**SIB 61 04 06**

SERVICE ACTION: Instrument cluster wiring harness chafing - 61 004 06 (054)

Subject: Instrument wiring harness chafed through or pinched

Model: R 1150 R

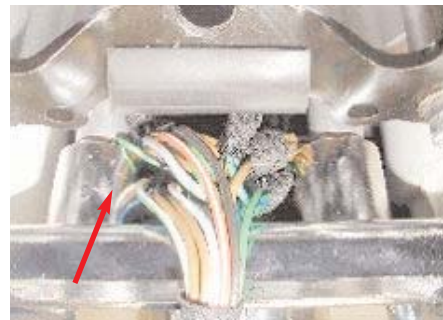
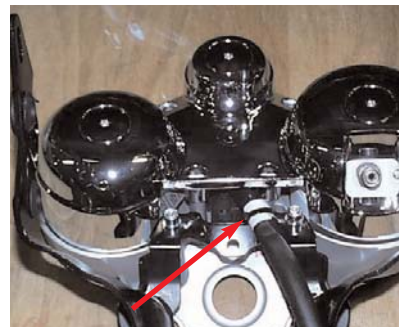
Details: There is a possibility of the wiring harness leading to the instrument cluster showing signs of chafing. In extreme cases this can result in a short-circuit. Individual cables in the instrument cluster can also become be pinched. See photos below.

1) The cable chafes against the holder of the instrument carrier. The cable tie is missing, or was incorrectly positioned by the supplier behind the insulating hose or the insulating tape.

2) The instrument cluster was incorrectly assembled by the supplier, with the result that individual cables were pinched on installation.

Production solution showing marking of the insulating hose.

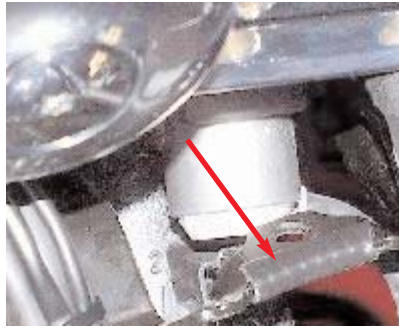
Production Solution: An edge protector was fitted to the frame of the instrument carrier as a provisional measure. The series solution entails correcting the position of the cable tie (supplier's scope of work). The tie has to be positioned in such a way that the insulating hose of the wiring harness extends a safe distance (approx. 30-40 mm/1.18-1.57 in) past the edge of the bracket of the instrument carrier (see photo on next page). To facilitate correct installation, the insulating hose was marked accordingly in series production.

Edge protector installed

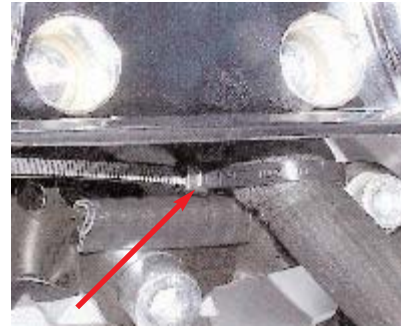
Note position of cable tie

The next time the motorcycle brought into the workshop, check the wiring harness of the instrument cluster for chafing and pinched wires. Install an edge protector, part number 51 46 7 019 965, and secure the wiring harness firmly to the instrument cluster by means of a cable tie (see photo above).

If the instrument cluster wiring harness is found to be damaged from chafing against the carrier, then replace the instrument cluster wiring harness.
